## CHAPTER 10-- CHANGES MADE TO TRAIL AND SNOWMAKING LAYOUT

This chapter describes changes made to the ski area design, in order to avoid landslides or minimize the impact of development on landslides. In the Progress Report on Geology and Slope Stability (GEO-HAZ, March 2007), we concluded that the proposed “Snodgrass Lite” design conformed with the 3 mountain-wide mitigation measures recommended by USFS (2006, p. 41). That is, no “structures, roads, buried utilities, and lift terminals [will be sited] on active (Class 1) landslides.”

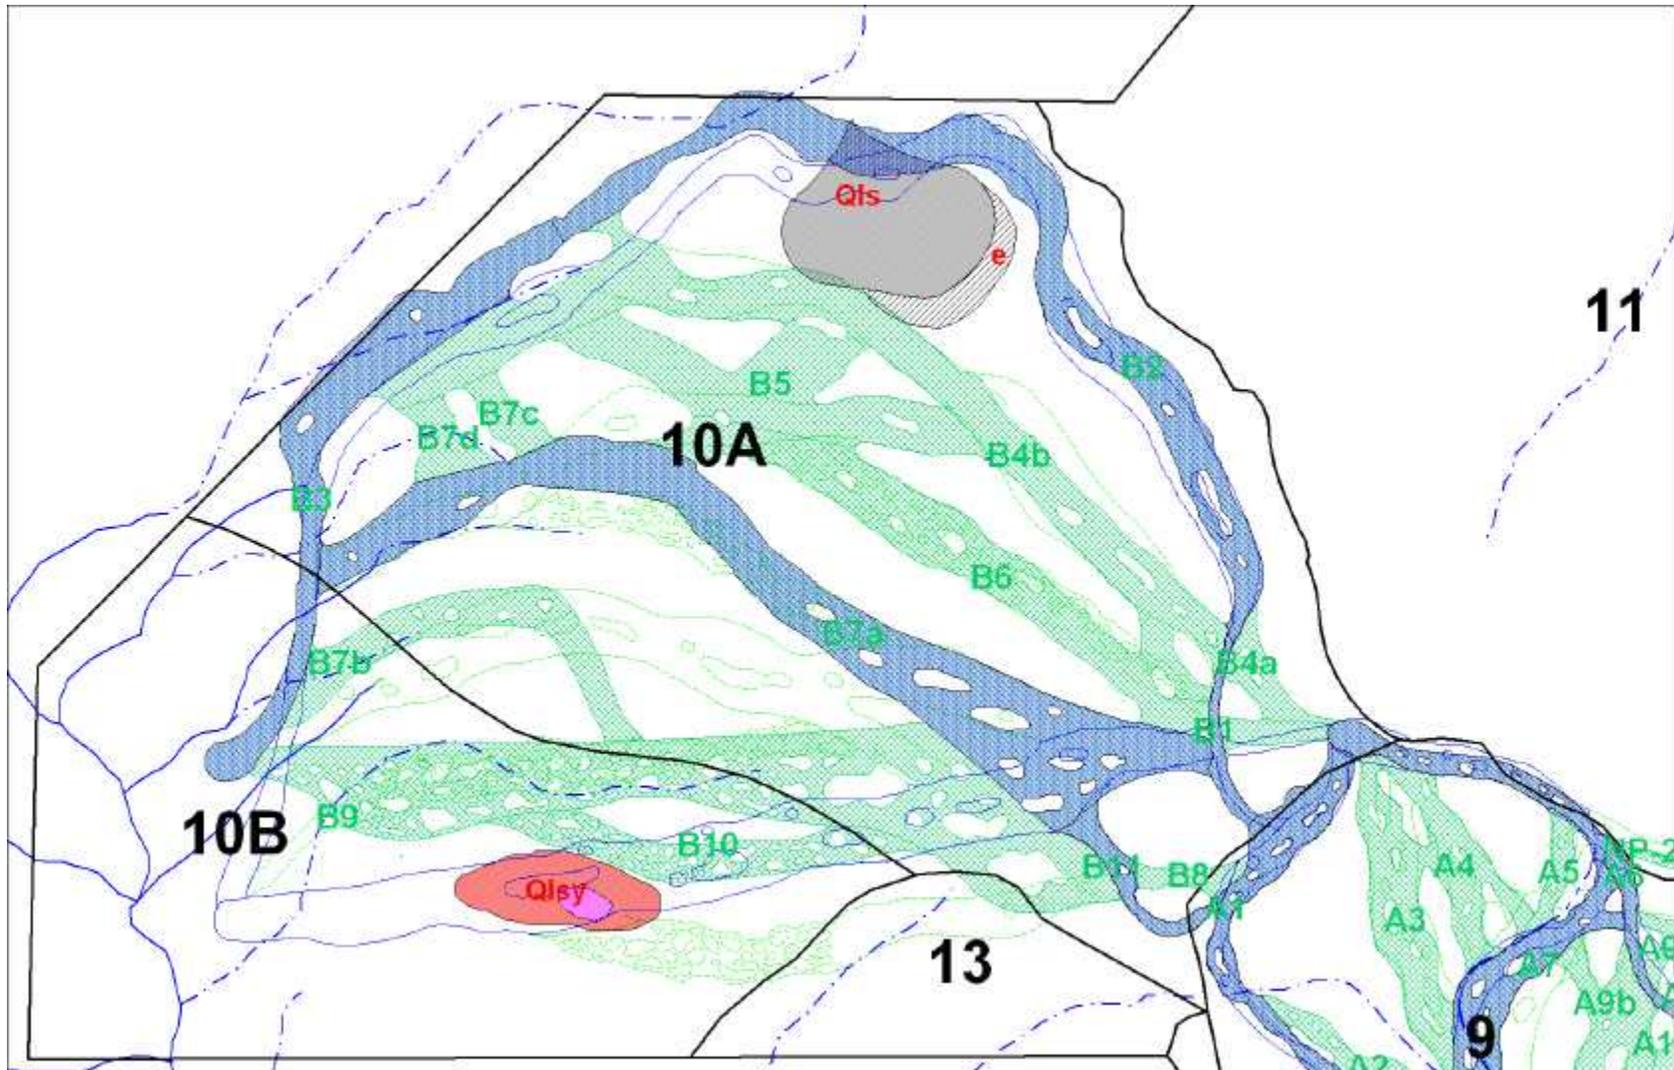
Table 7-1 shows 3 additional levels of avoidance, in order of increasing margin of safety and conservatism, which have been considered by CBMR and included by IAD into the current ski area design. Level 2 expands the list of prohibited actions on active landslides from 4 to 7, to include snowmaking, trail clearing, and lift towers. At this increased level of safety, the original Snodgrass Lite proposal has 3 conflicts with geologic constraints (all at the same location on the West Face), where proposed Trail 31 (with snowmaking, and a lift line) crossed over an active landslide (Qlsh and Qlsy, polygons 45-46, GHU 10A). Therefore, in the revised Snodgrass Lite design (trails, 30-NOV-2007; snowmaking, 25-OCT-2007), this trail and lift were shifted northward onto a stable bedrock ridge, such that neither the trail nor lift intersects either polygon 46 (active) or 45 (young) (Fig. 10-1). This shift eliminates all conflicts at Level 2.

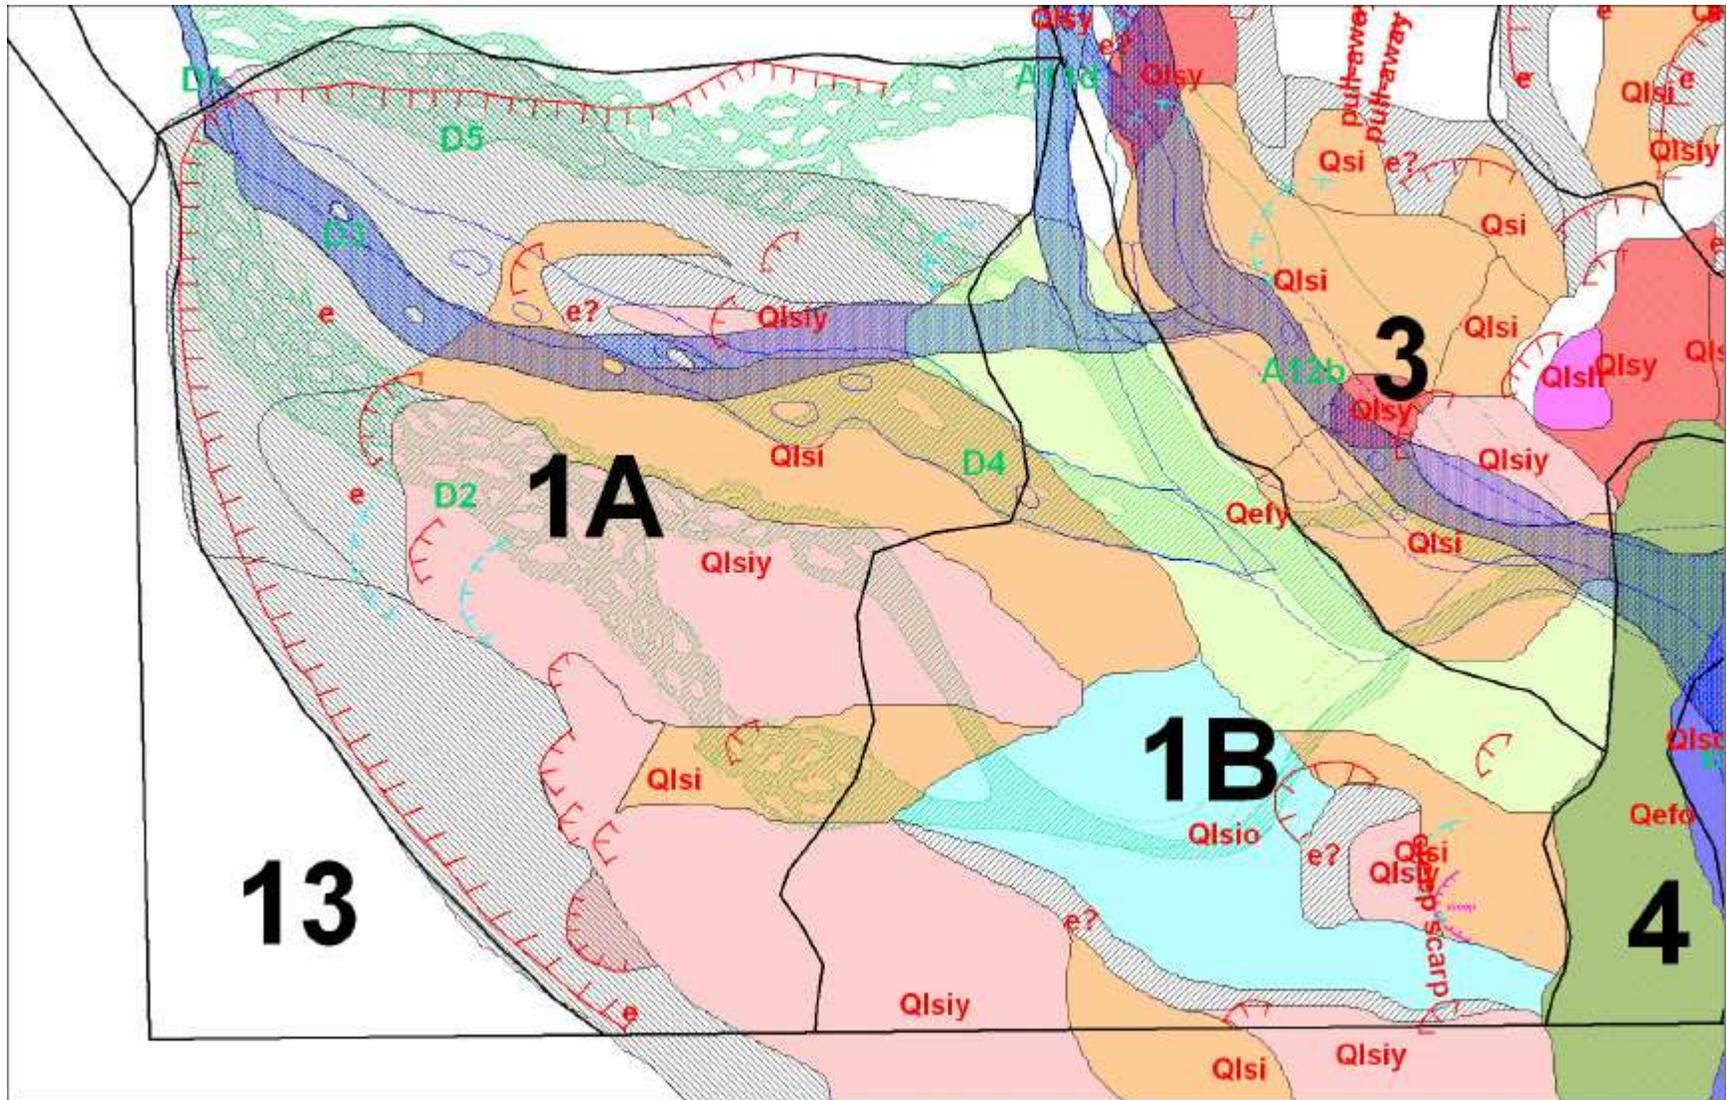
**GHU 1A—Conflict #1;** The original alignment of Trail D4 (with snowmaking) intersected 2 “prominent scarps” mapped by RCE (1995) in polygons 2 (Qlsi) and 10 (Qlsiy), which presumably mark younger slump reactivations in those polygons (Fig. 10-2). To eliminate this conflict, Trail D4 was shifted south in its upper part to avoid the scarps (red hachured lines in Fig. 10-2) and to remain mainly on the ridge-like landform of more stable landslide polygon 2. In its lower part Trail D4 was shifted north, to avoid Conflict #2 (next section).

**GHU 1B—Conflict #2;** The original alignment of Trail A11d (with snowmaking) ran southward from Ken’s Crux, down the eastern part of landslide polygon 1, the young earthflow (Qefy). This alignment created a significant conflict with landslides, even at Level 4, because even though the young earthflow is not currently moving, it has a low calculated Factor of Safety related to artesian aquifers at its base (PZ-6A). To diminish this conflict, snowmaking was removed from all of Trail A11d except for the upper 340 ft of polygon 1 (Fig. 10-2), which is the most stable part (Qefi; see Chapter 8 for cross-section). This action removed 900 ft of snowmaking from Trail A11d on polygon 1. The Trail will still exist, but it involves no snowmaking and little trail clearing, because that part of polygon 1 is mainly unforested. An additional 340 ft of snowmaking was removed from polygon 1 by the northward shift of Trail D4. Together, these two actions decreased the amount of snowmaking proposed on polygon 1 from 4.0 acres to 1.7 acres, a decrease of 58%.

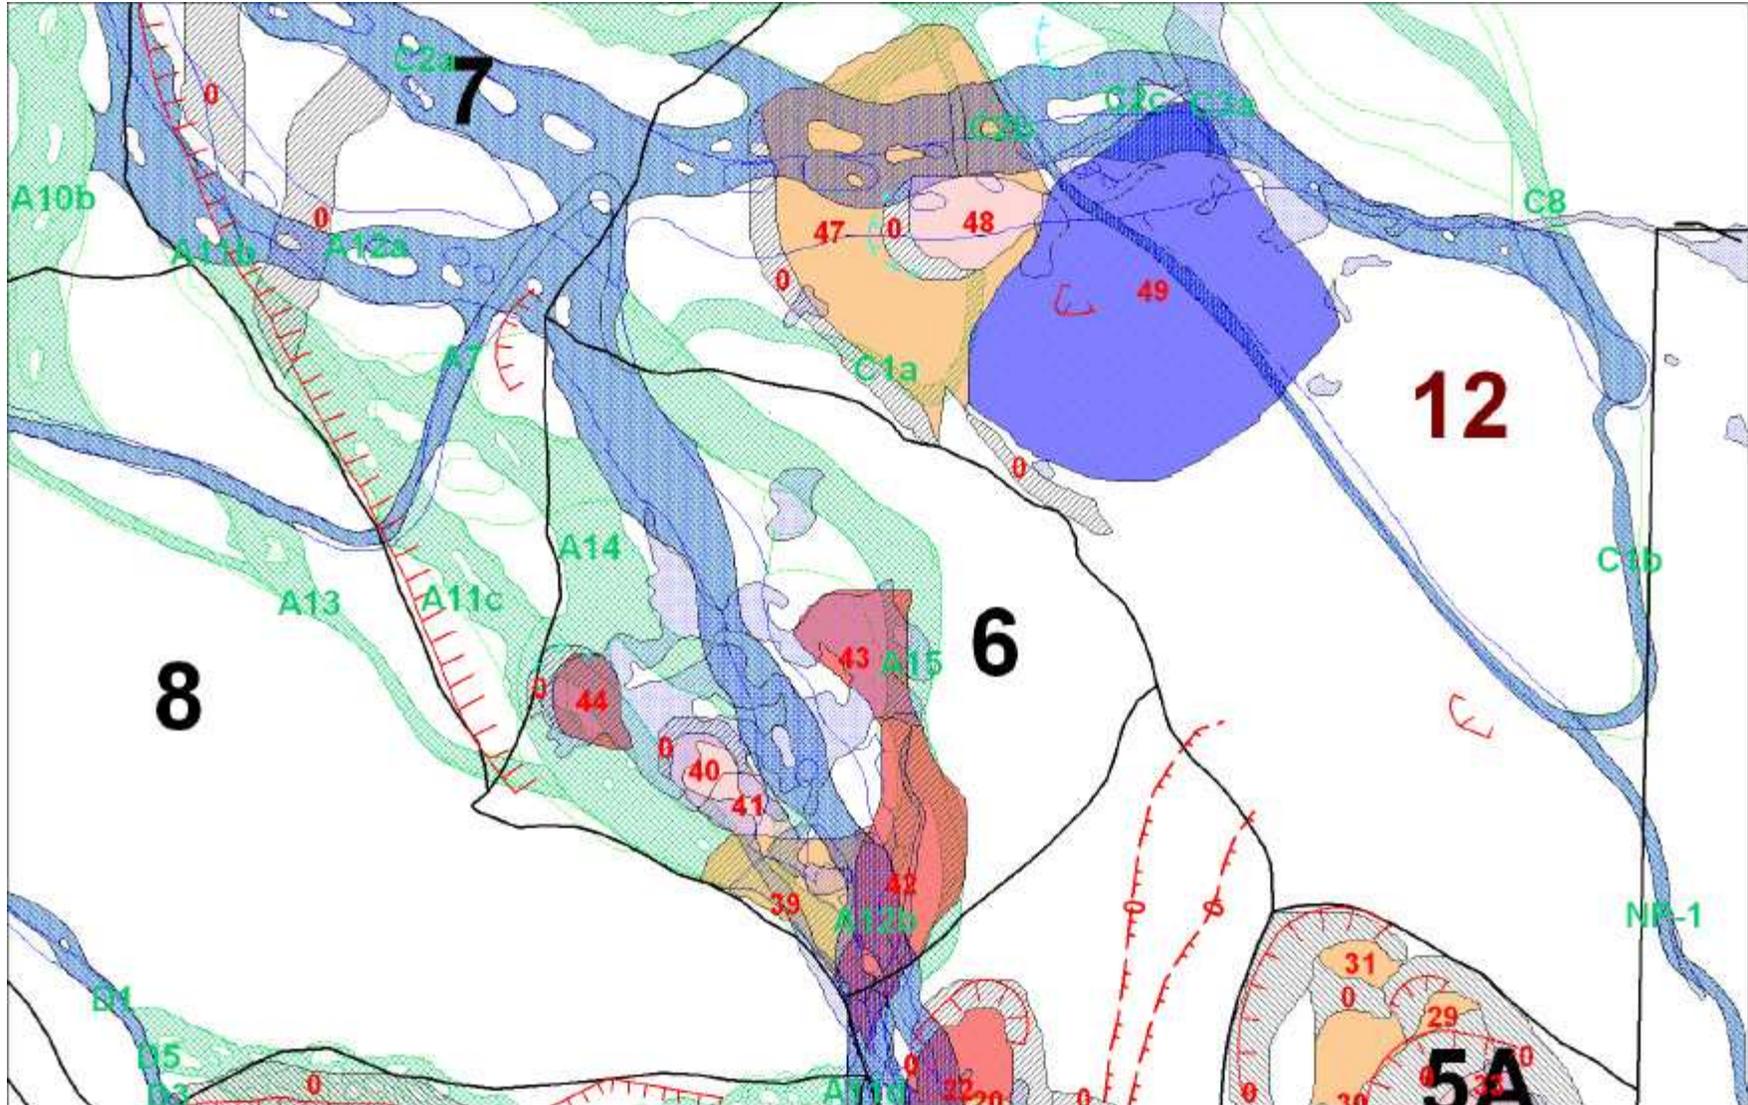
GHU 6—Conflict #5; Above Ken's Crux, Trail A11c (no snowmaking) splits apart from Trail 12, and was proposed to cross the western edge of polygon 44 (Qlsy). Therefore, Trail A11c will be shifted west to avoid this.

Conflict #6; Trail A15 (no snowmaking) covers the eastern edge of polygon 43 (Qlsy) for a distance of 340 ft, and the center of polygon 42 (Qlsy) for an additional 800 ft. However, this is not as bad as it looks. First, Trail A15 will not have snowmaking. Second, the 340 ft of Trail 12A on polygon 43 can be shifted east only 50 ft to avoid the polygon. Third, on polygon 42, the trail cannot be shifted, so aggressive surface-water mitigation will be performed in the Chicken Bone meadow above, moving runoff to the east.

GHU 12—Conflict #7; Trail 13 (snowmaking on southern half) was proposed to cross an old (RCE) scarp and polygon 48 (Qlsiy). Although these two landslide features are, strictly speaking, too old to be considered in Level 4, it was relatively easy to shift the snowmaking to the northern half of Trail 13. This action moves all the snowmaking onto stable bedrock terrain.
